Supplement to Final Environmental Statement

related to construction and operation of
Clinch River Breeder Reactor Plant

Docket No. 50-537

October 1982

Figure A3.6 Perforated pipe intake system (replaces FES Fig. 3.8)

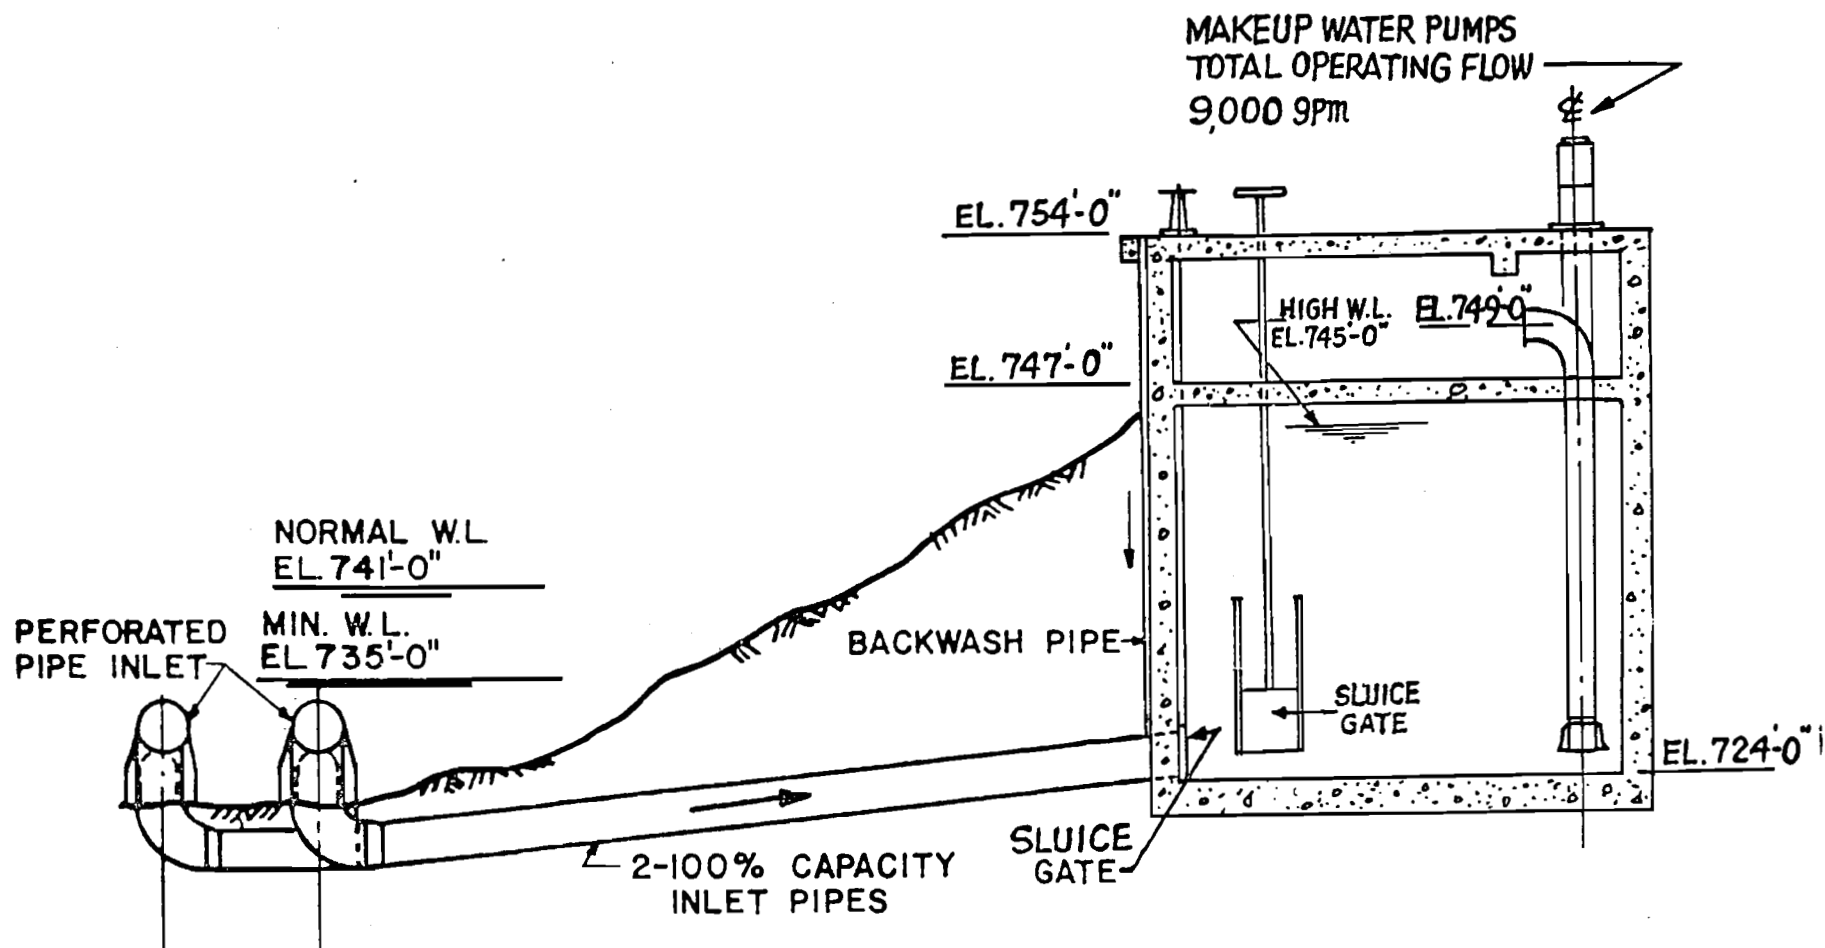
The description of the plant water intake has been modified and expanded. The top of the intake structure now will be 8.5 ft above river bottom rather than 8 ft (see Figure A3.6, which replaces FES Fig. 3.8).

Figure A3.7 Liquid radioactive waste system
(replaces FES Fig. 3.15)

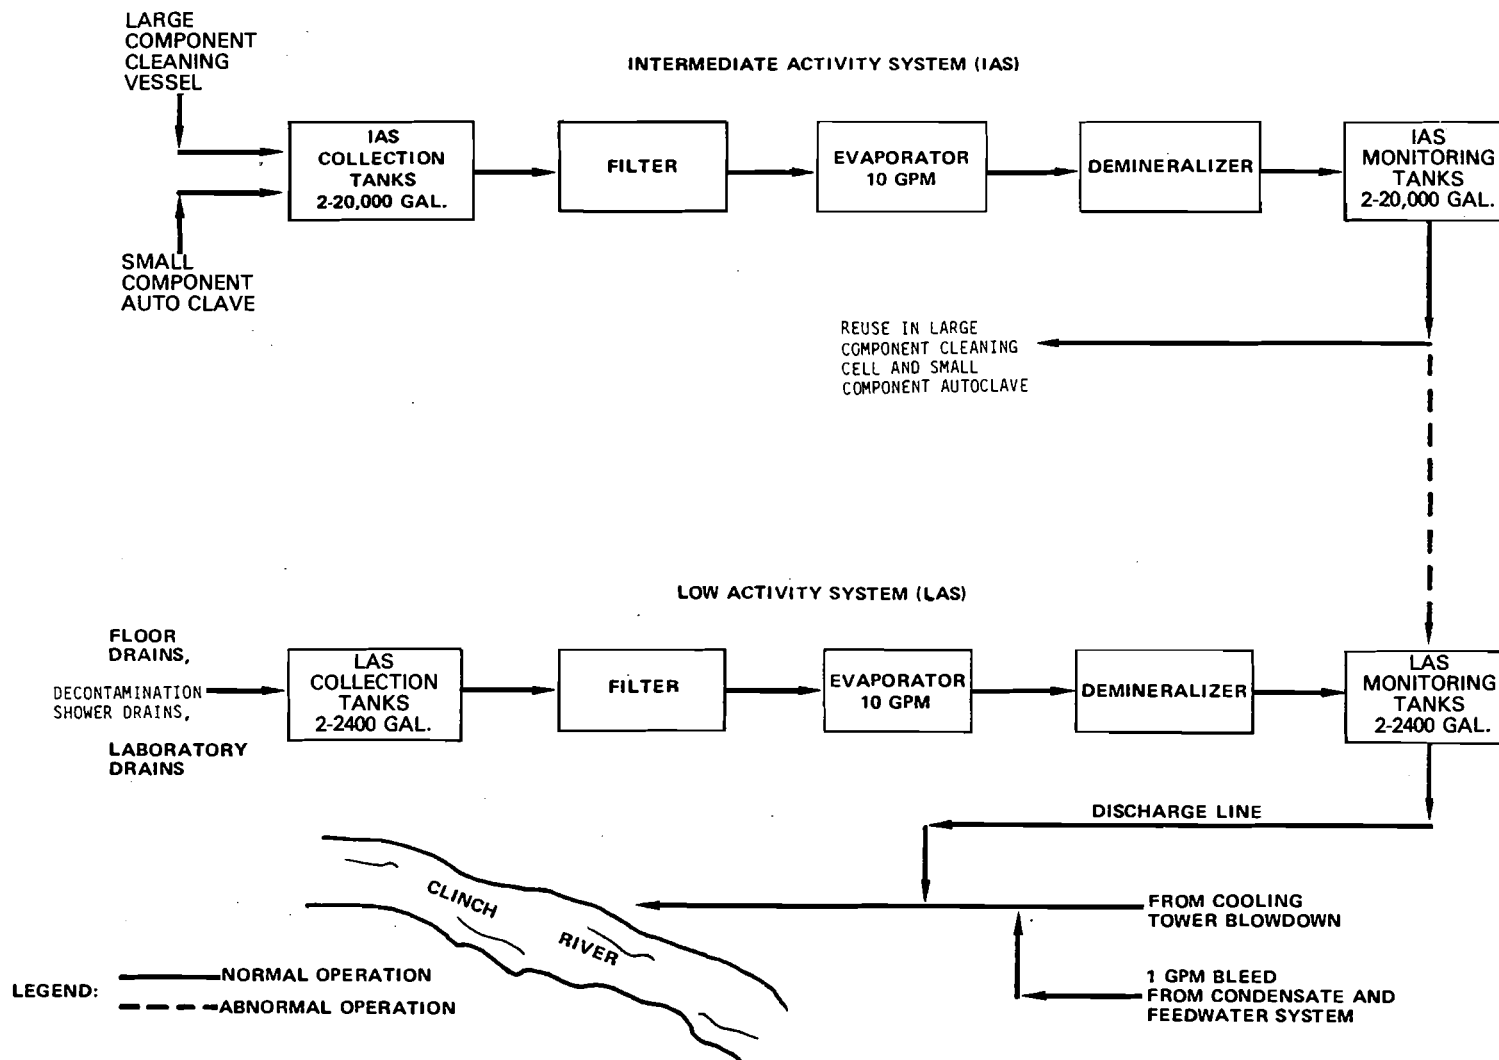
The input flow rate for the aqueous waste to be collected in the IAS collection tanks (which hold 20,000 gal each) is now estimated to be 340 gpd instead of the 400 gpd indicated in the FES (see Figure A3.7, which replaces FES Fig. 3.15 revised). The staff calculates the collection time to be 59 days. After collection, the waste would be processed, in batches, by filtration, evaporation (10 gpm), and demineralization before it is collected in one of the 20,000-gal monitoring tanks.

Figure A3.8 Gaseous radioactive waste systems and CRBRP ventilation (replaces FES Fig. 3.16)

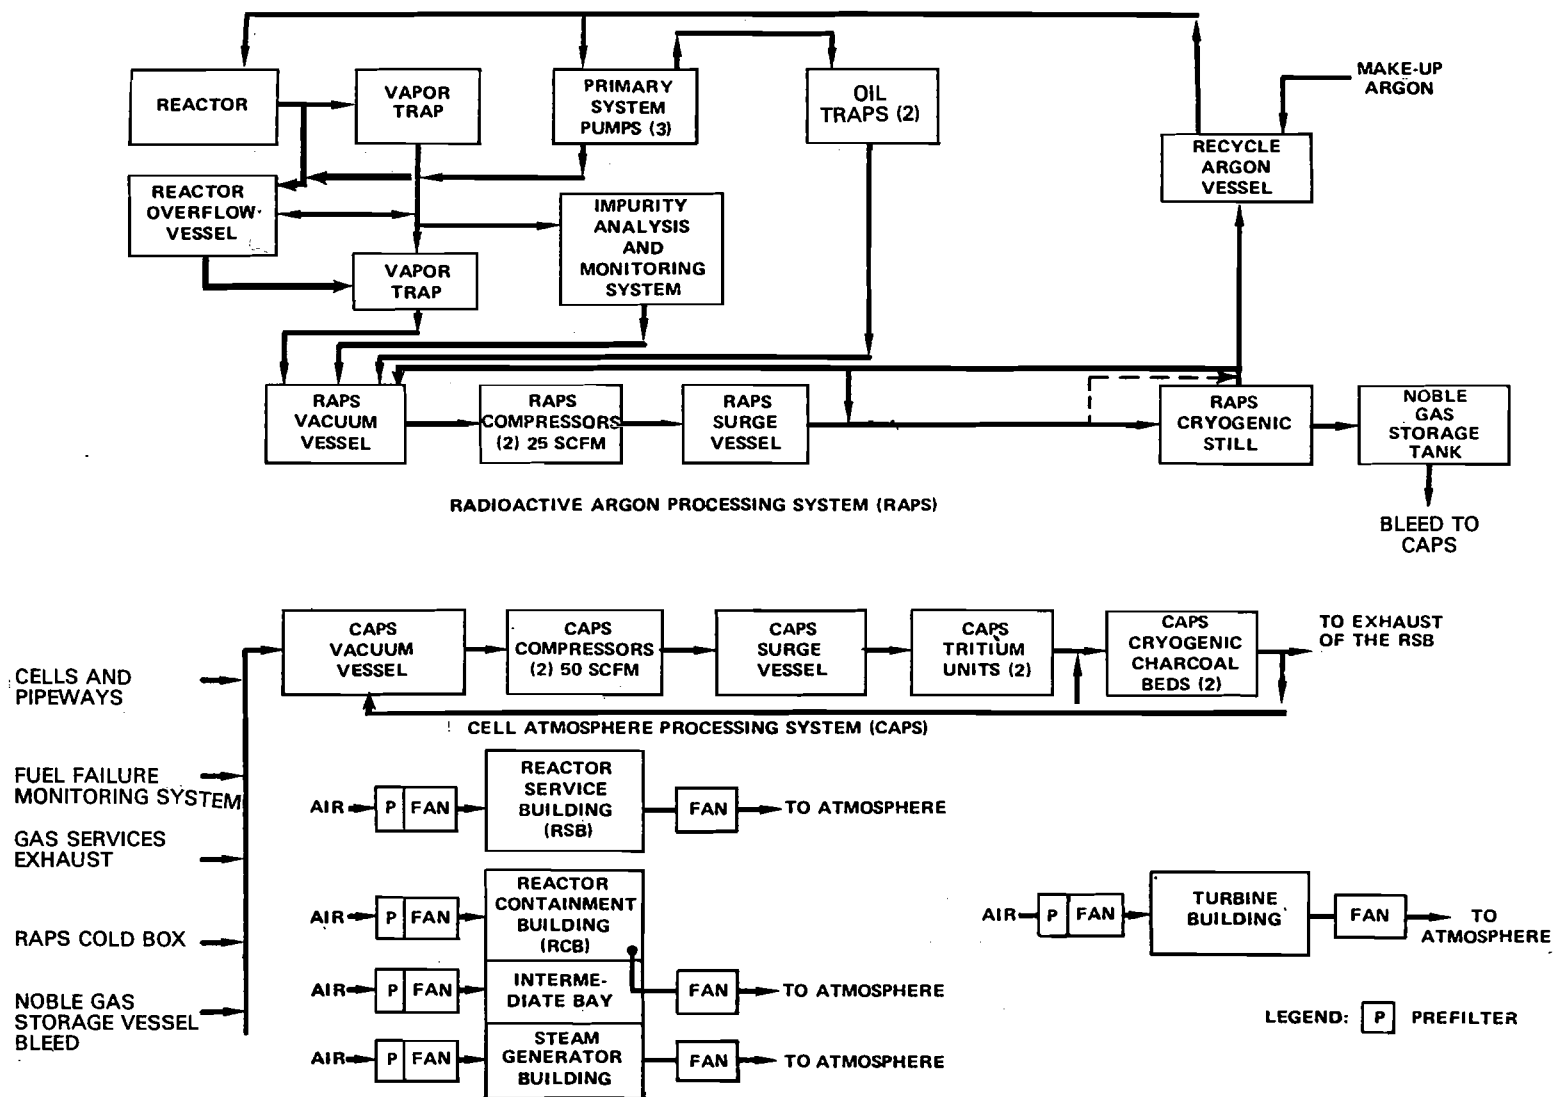
Changes in FES Figure 3.16 (herein Figure A3.8) are discussed below. In the first sentence of the text, "store" has been deleted.

The radioactive argon processing system (RAPS) would continuously process and recycle the primary sodium system cover gas (argon) and provide a source of low radioactivity gas for use in reactor seals. In the process, as revised from that described in the FES, radioactive cover gases from the spaces in the reactor, reactor overflow vessel, and primary system pumps would be collected in the vacuum vessel and transferred by compressor to the surge vessel where they would be stored under pressure (Figure A3.8). The RAPS recycle system would consist of a vacuum vessel, two compressors, a surge vessel, a cryogenic still, a noble gas storage tank, and a recycle argon vessel.

Figure A4.1 Proposed site construction layout

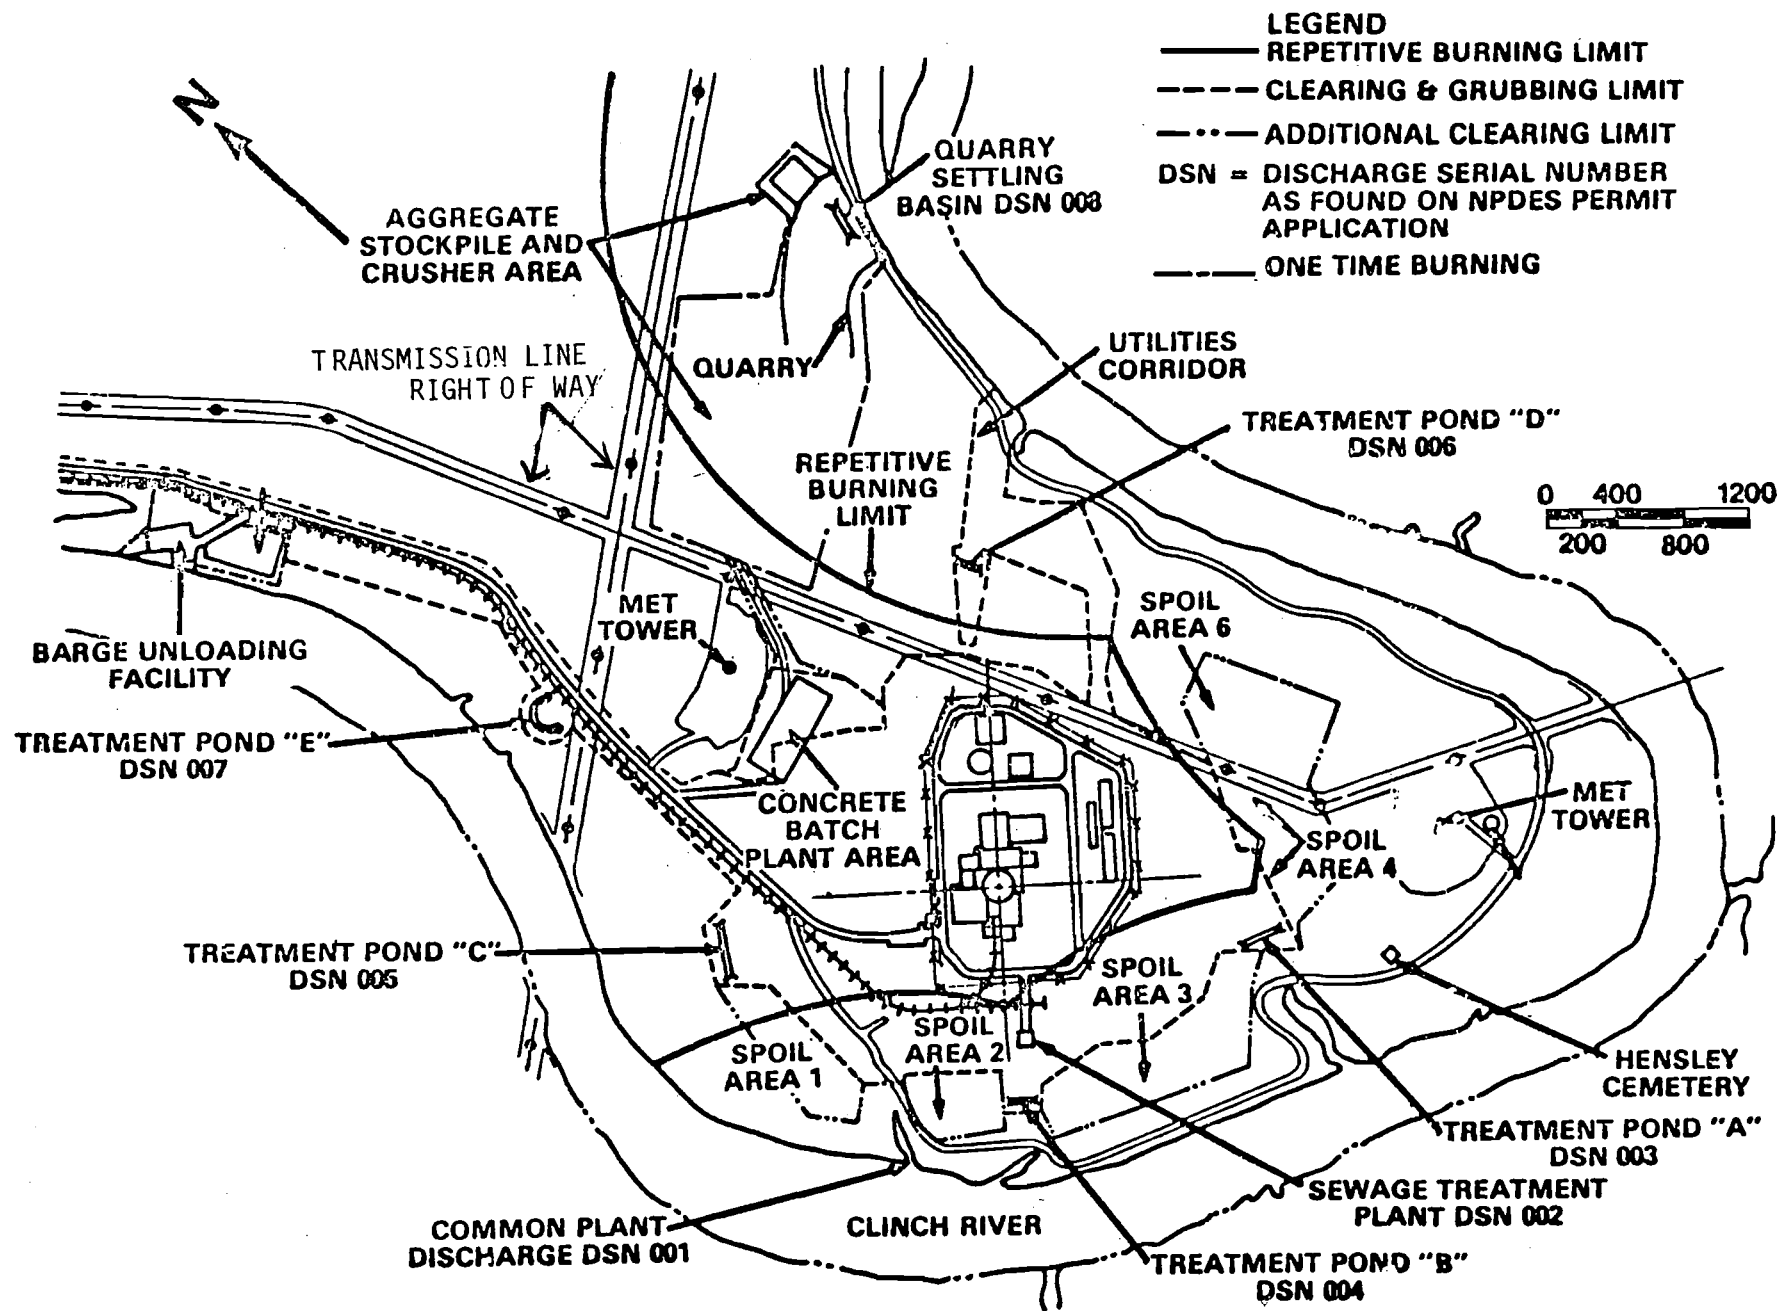
The facilities to be constructed during site preparation are essentially as described in the FES. The 32-acre borrow pit shown in FES Figure 4.1 has been eliminated and the 25-acre quarry would now occupy 45 to 60 acres (Figure A4.1).

The barge-unloading facility (Figure A4.1) has been redesigned in a manner which minimizes dredging. The concrete-slab-on-piling type of barge-unloading

NRDC-26b--Indian Burial Mound: The comment was noted and the Indian Burial Mound has been deleted from Figure A4.1 of the FES supplement. The incomplete sentence noted in this comment has been corrected.

Figure A6.3 River sampling transects for the baseline aquatic monitoring program (replaces FES Fig. 6.3)

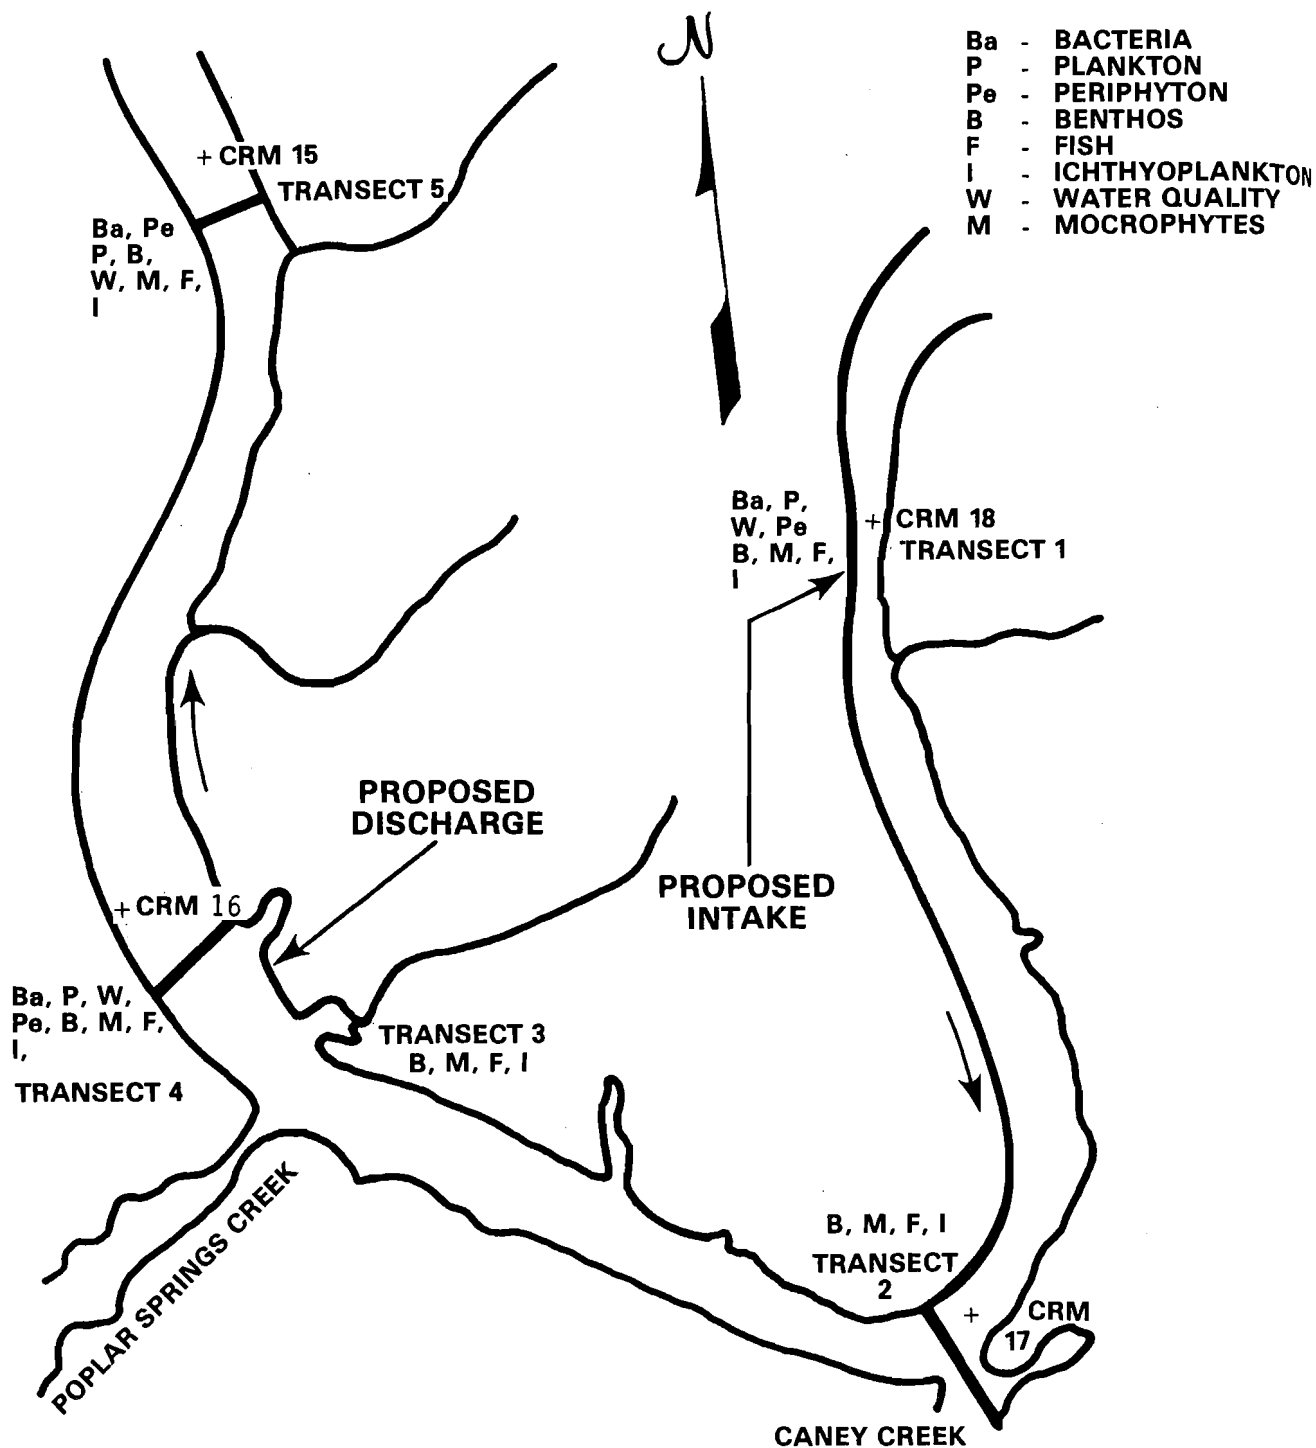
EPA-15--Figure A6.3: The correction has been made.

Figure A6.4 Reservoir environmental monitoring network, preconstruction-construction phase

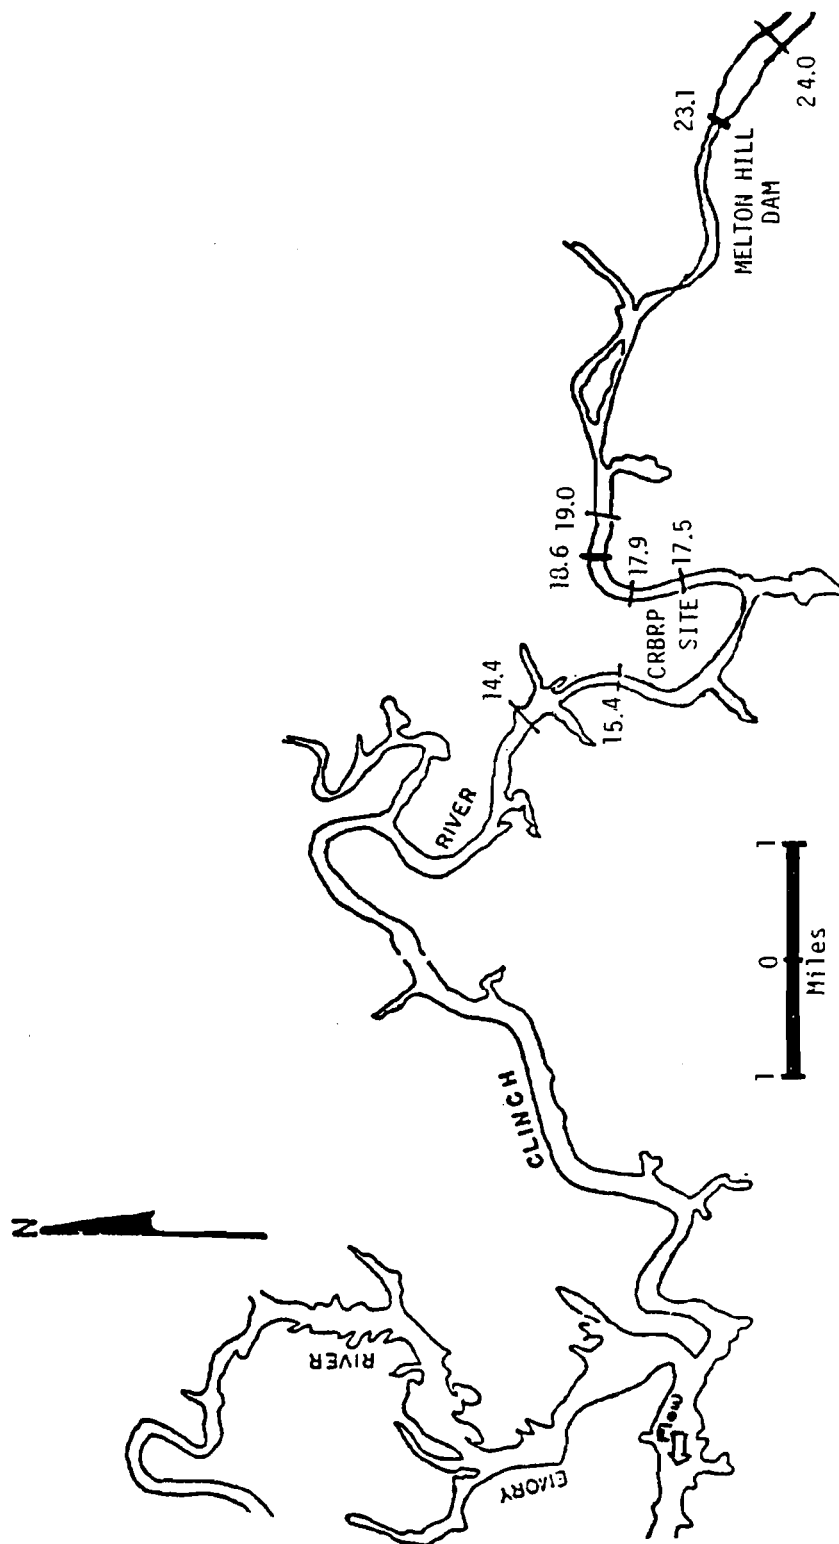
CRM 14.4, both downstream from the site (see Figure A6.4, which supersedes FES Figure 6.4) (ER Fig 6.1-11). The additional data gathered after January 1978 were considered in updating Chapters 2, 3, 4, and 5 of this document.
